ND-2012-0007
January 25, 2012

Subject: **PSEG Early Site Permit Application**
Docket No. 52-043
Response to Request for Additional Information, RAI No. 44, Surface
Faulting

RESPONSE to RAI No. 44

Lineament Investigation with Track
Logs and Waypoints Overlain
FIGURE RAI-44-4-2

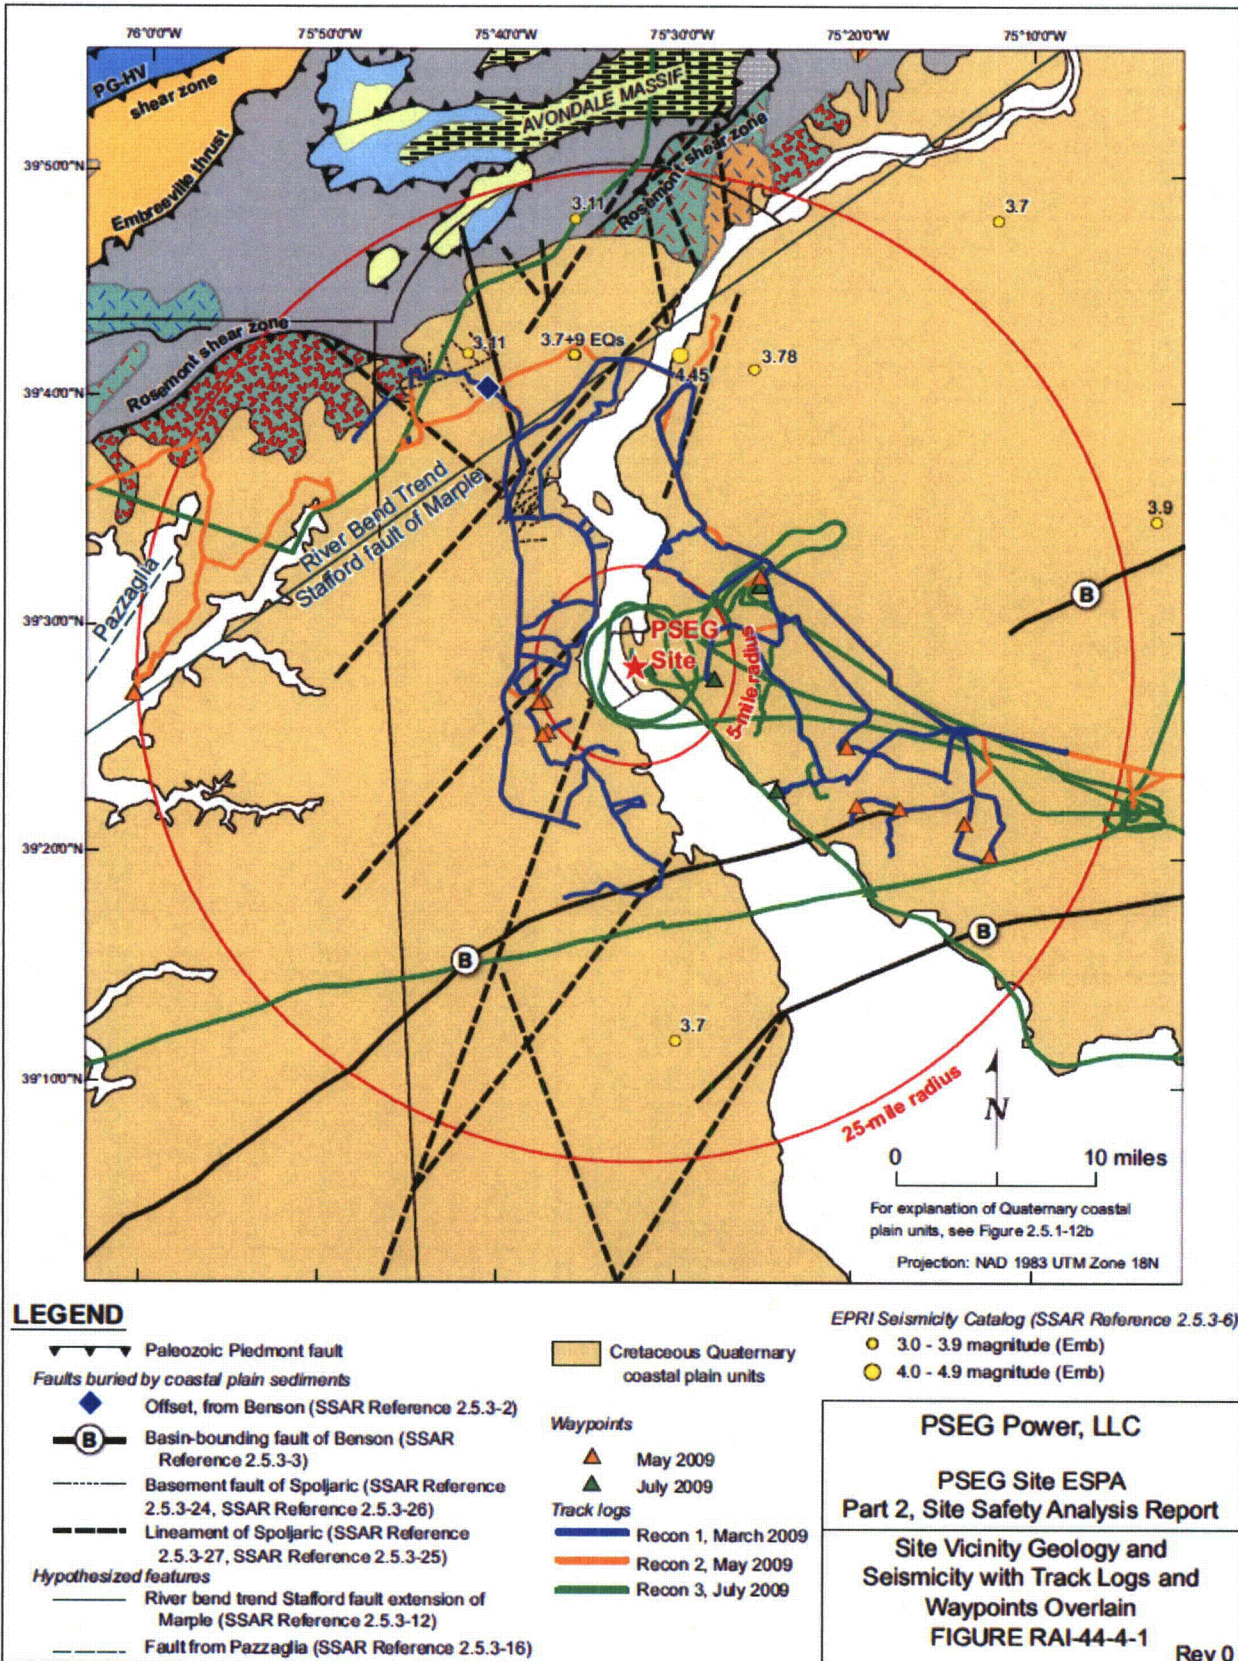
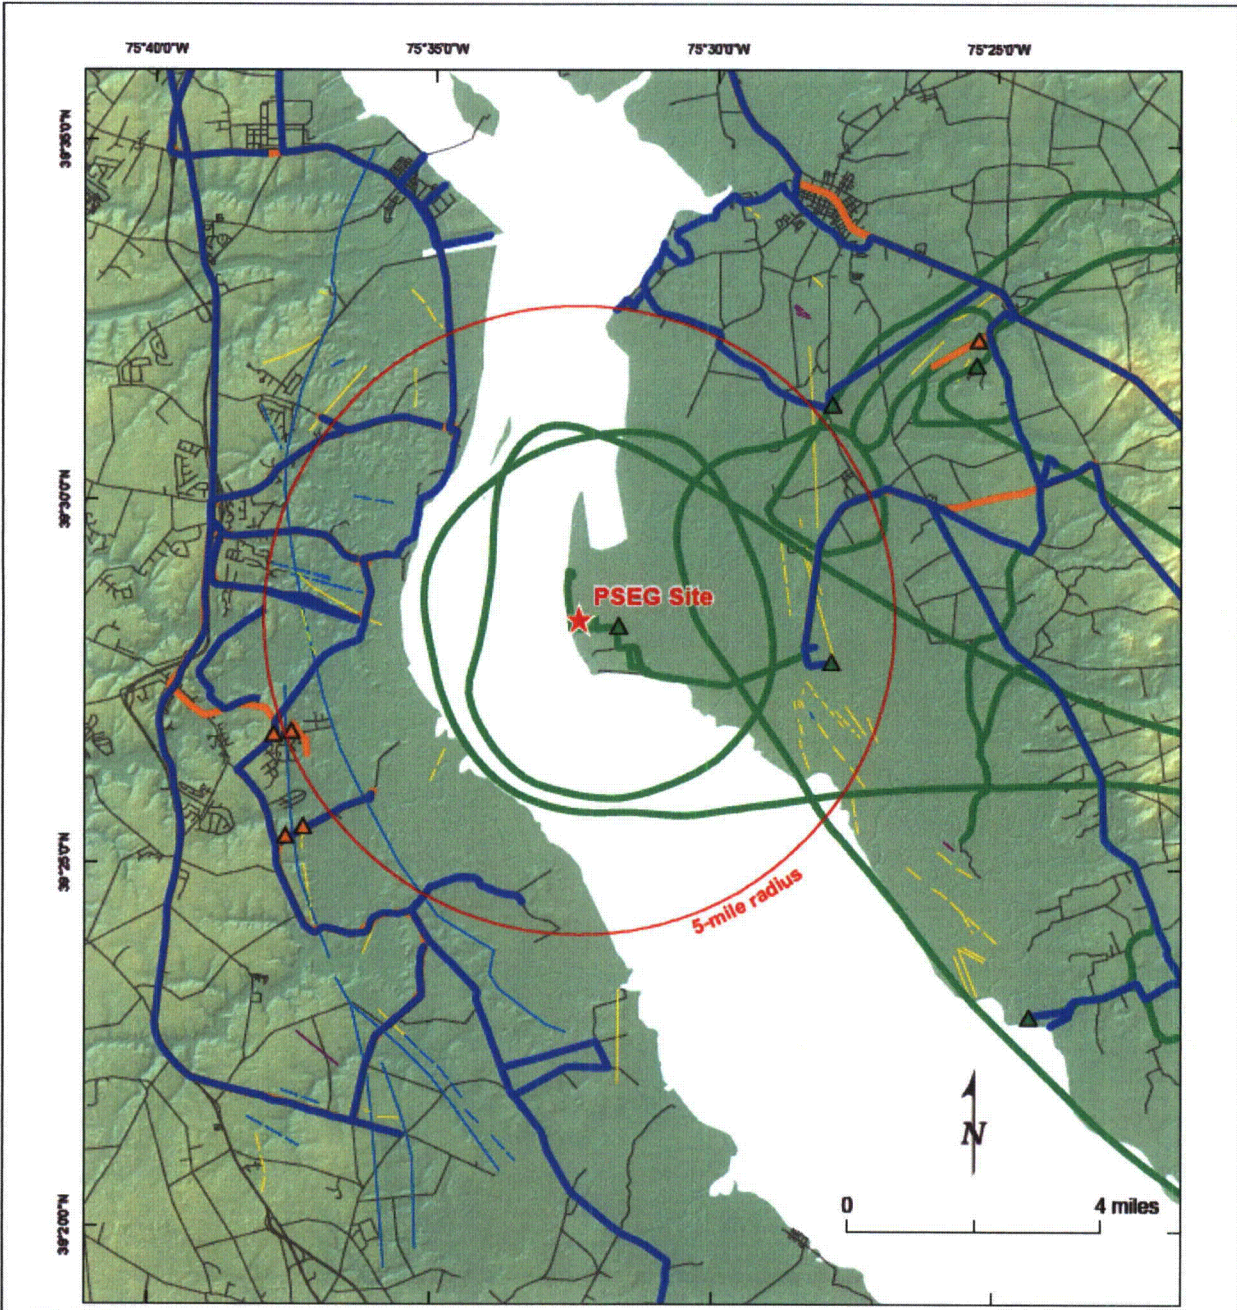
SSAR Subsection 2.5.3.1.5, "Aerial Imagery Analysis," discusses lineaments trending into the site vicinity based on historical (1930s) and modern (2007 and 2008) imagery, two of which also extend into the site area. The SSAR concludes that none of the "identified and accessible" lineaments investigated showed tectonic or geologic features indicative of surface faulting. Upon reviewing SSAR Subsection 2.5.3.1.5 and SSAR Figure 2.5.3-1, it is not clear to the staff which lineaments were physically investigated in the field and which lineaments were considered inaccessible.

In order for the staff to adequately evaluate the potential for faulting within the PSEG site vicinity and at the PSEG site, and in compliance with 10 CFR 100.23 and in conformance to NUREG 0800, Section 2.5.3, "Surface Faulting," please clarify the process used to document the conclusion that none of the lineaments in the site vicinity or site area showed tectonic or geologic features indicative of surface faulting. Please identify which lineaments were evaluated in the field and which features were determined to be inaccessible. In addition, please describe what approach was applied to evaluate those features that were determined to be inaccessible in the field.

Ground reconnaissance in the site vicinity and site area was performed in March, May and July, 2009. An aerial reconnaissance was performed in conjunction with the July, 2009 ground reconnaissance. Figures RAI-44-4-1 and RAI-44-4-2 show locations of lineaments in the site vicinity and the site area, respectively, along with the track log for ground and aerial reconnaissance. In addition, waypoints are indicated on the figures that mark locations at which stops were made to examine specific features on foot. This ground and aerial reconnaissance evaluated lineaments in relation to their possible origins such as alignment of vegetation or possible association with surface deformation. Typical views at ground level for some of these features are shown in Figures RAI-44-4-3 through RAI-44-4-7. In all cases, as examined from the air and ground, no association with surface deformation was found. Almost all of these lineaments are completely or partially located in salt marsh or private land that is not accessible from the ground (i.e., "in the field"). Therefore, the only access for observation was by air.
